PlanGrid Task Report - Oct 6, 2025

Prepared by Stephen Tassinaro

27 tasks in this report.

#493 [UNIT 499] [NEW] CRITICAL - RTU-1 Alarms

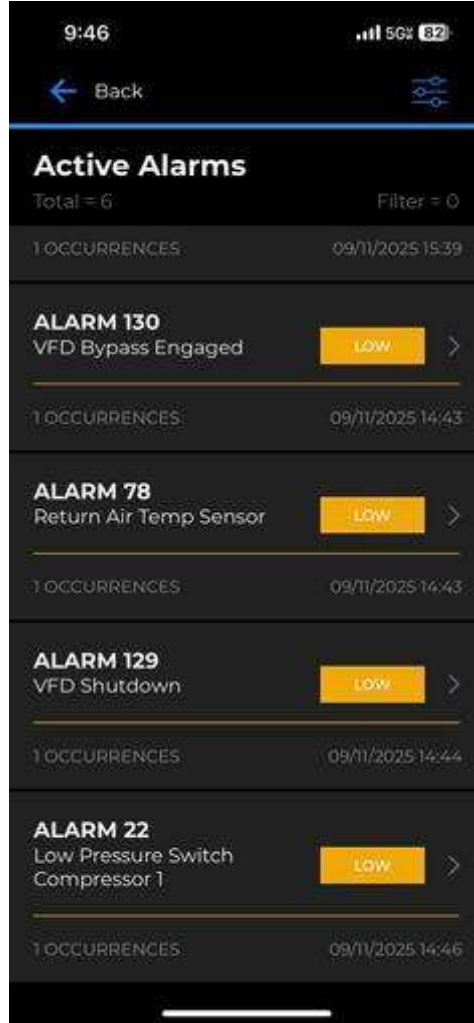
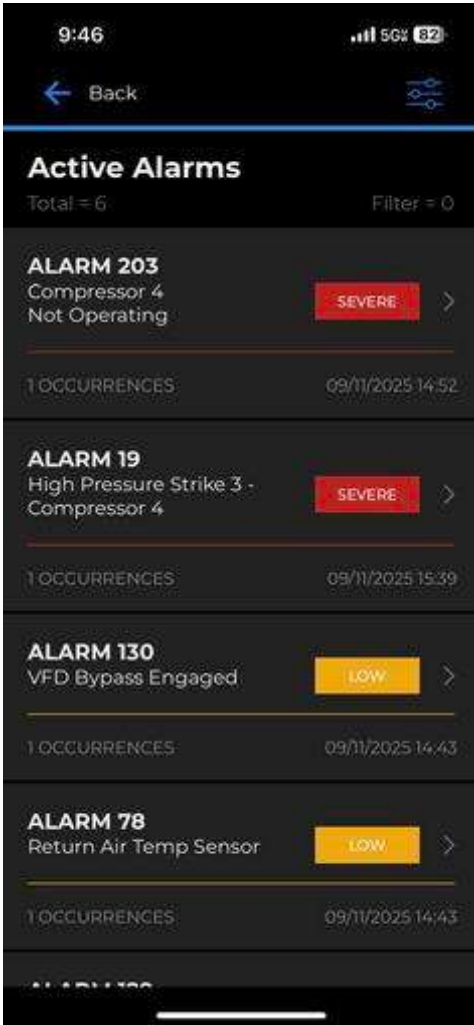
RTU-1 has multiple critical alarms concerning the VFD and compressors. VFD has been bypassed prior to NTi arriving on site.

All alarms are still present. Unit needs service ASAP.

#492 [DUCT 006] [NEW] CRITICAL – Flex duct installation RTU-1

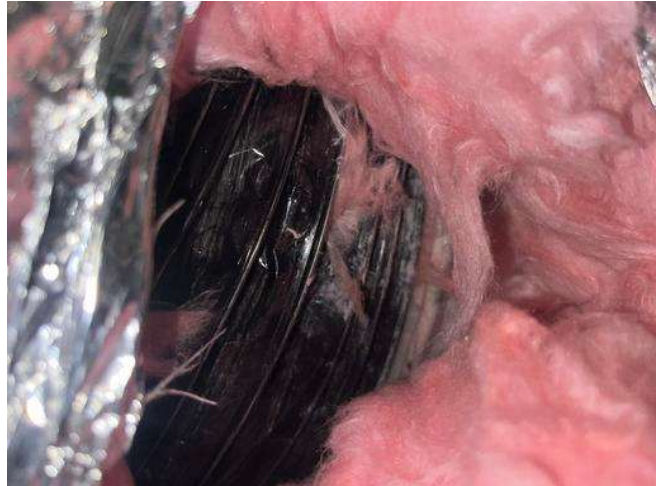
Ensure flex inner core is taped and banded, along with tape or banding on outer insulation jacket.

Mastic has been applied to the outer insulation jacket but the inner cores only have draw bands to secure them.

#490 [CNTL 017] [NEW] CRITICAL Thermostat terminations incorrect.

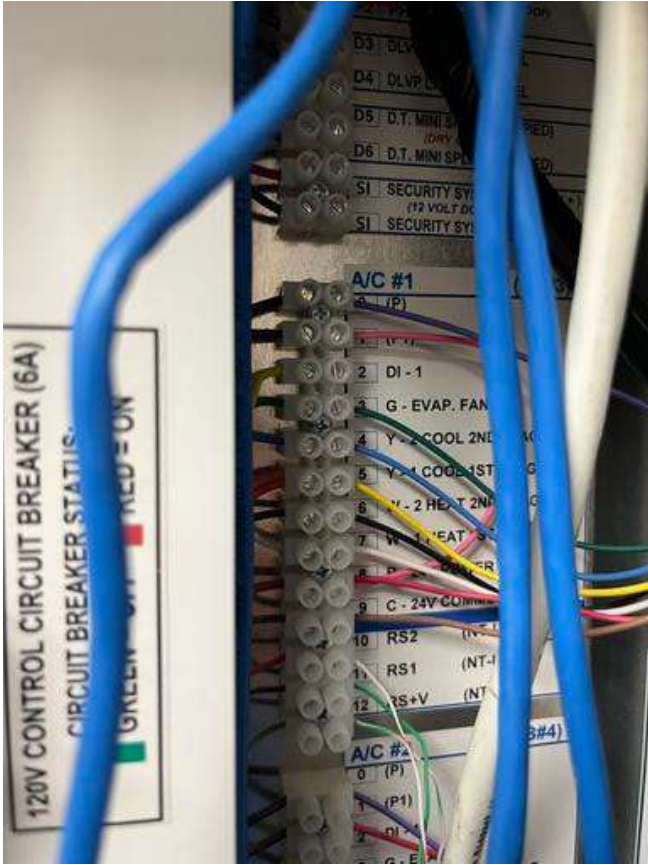
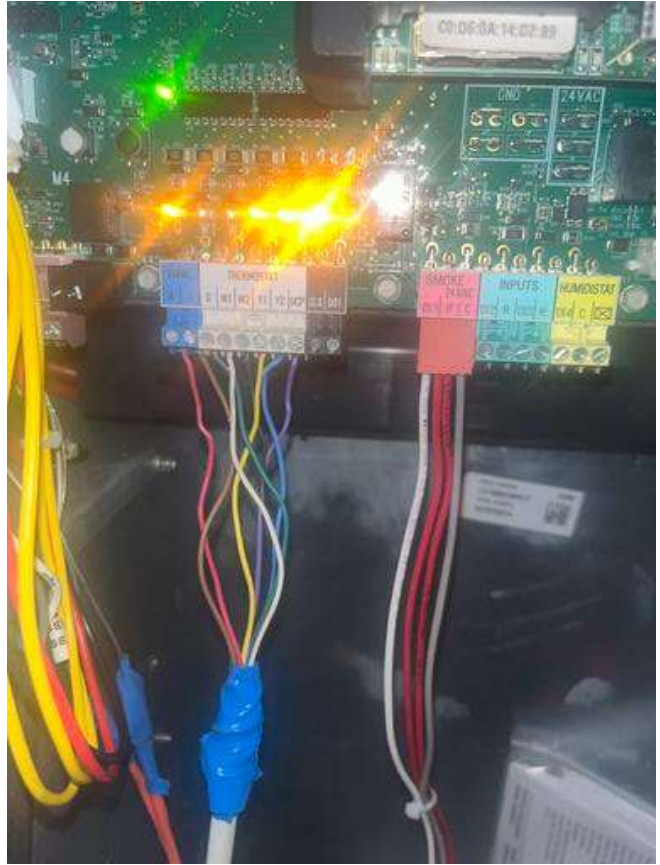
D1 terminals not landed.

Unresolved.

#488 [EXHA 999] [NEW] KEF High Voltage Wiring

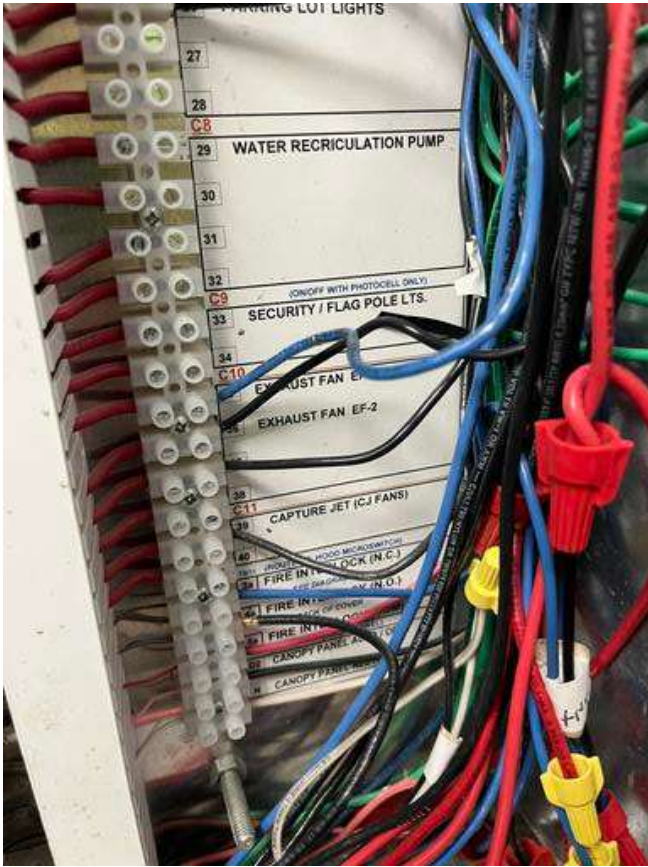
The high voltage wiring for the kitchen exhaust fans does not appear to be correct. EF-2 (HD-2) is landed at the EF-1 terminal. EF-1 and EF-4 are both landed at an unlabeled terminal (#37). The actual EF-2 terminal has a wire landed but there was no load measured.

#317 [EXHA 001] [NEW] CRITICAL – Grease duct access doors.

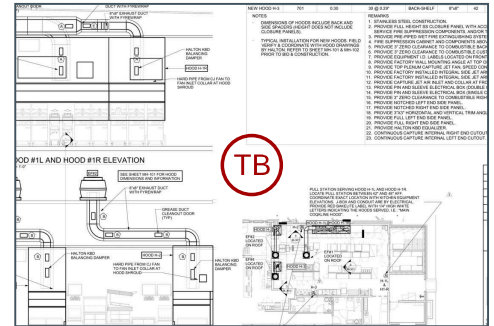
Total number of access doors installed per grease duct is less than that shown on MSET.

Attached photo is of Hood 3 grease duct, recommend verifying all grease ducts have correct access panels.

Hood 3 duct has 1 of 3 grease cleanout doors. Hood 2 has 3 of 4 grease cleanout doors. None of the access doors have appropriate hardware or gaskets. Review all.

#294 [UNIT 002] [EXIST] CRITICAL – Unit evaporator is plugged. RTU-2, RTU-3, RTU-4

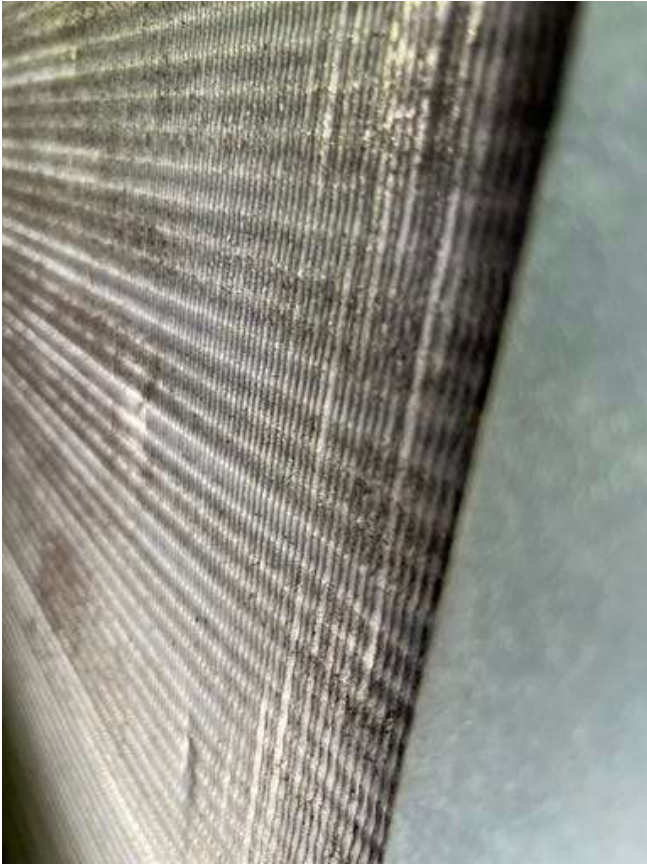
Unit evaporator is clogged with debris and must be cleaned before balance can continue.

All existing units still have dirty evap coils

Unresolved. Particularly high fan suction pressure on RTU-3 (-1.18”) but all units will benefit from deep cleaning.
